PLANNED UNIT DEVELOPMENT

STAFF REPORT Date: September 1, 2011

DEVELOPMENT NAME Persons Development

LOCATION 4474 & 4480 Halls Mill Road

SITE PLAN

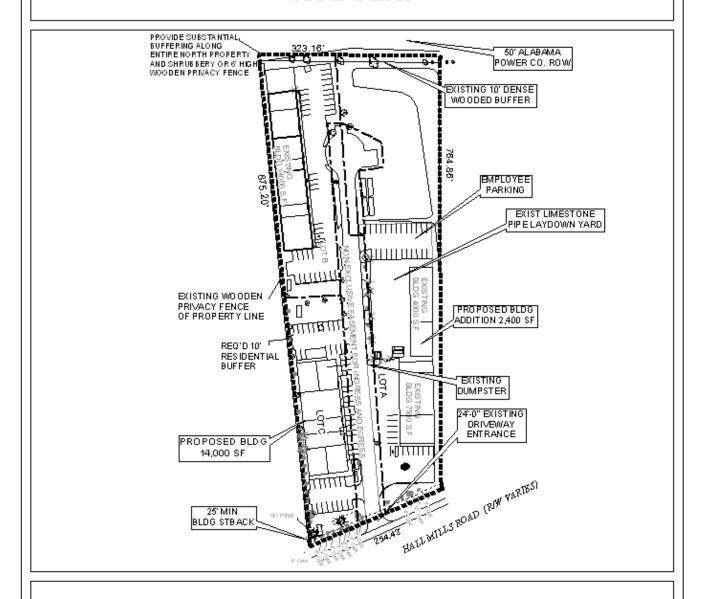
The applicant submitted a revised site plan. The revised site plan indicates that the site will comply with the parking requirements of the zoning ordinance, as well as the landscaping area requirements of the ordinance.

The site plan also indicates a limestone laydown yard and temporary storage of construction containers. There is no variance on file for the limestone laydown yard, as this type of surfacing is not allowed in a B-3 zoning district. As such, a variance from the Board of Zoning Adjustment would be necessary for the laydown yard to remain.

The site does not meet the front landscaping area requirements. The plan depicts a shortage of 5,323 square feet, which is about the size of the southernmost parking lot on Lot C. Removal of this parking lot from its current location and placement of the parking elsewhere on the site would allow compliance with the frontage landscaping requirements.

Regarding the turnaround, the Fire Department has advised that a 96-foot diameter turnaround will be necessary. The existing turnaround does not meet this requirement, and, as such, the plan should be revised to indicate this.

- 1) submittal of a variance from the Board of Zoning Adjustment for the limestone laydown yard;
- 2) modification of the site plan to depict a cul-de-sac with a 96-foot diameter cul-de-sac, and construction of said cul-de-sac;

- 3) modification of the site plan to obtain compliance with the Tree Planting and Landscaping Area requirements;
- 4) compliance with Engineering comments: "Engineer needs to confirm that detention is provided for all impervious area added since 1984 and shall also certify that the existing detention pond is adequately sized, functional and stable prior to approval of any building permit. Must comply with all storm water and flood control ordinances. Any work performed in the right of way will require a right of way permit. Drainage from any dumpster pads cannot discharge to storm sewer; must have connection to sanitary sewer;" and
- 5) full compliance with all municipal codes and ordinances.
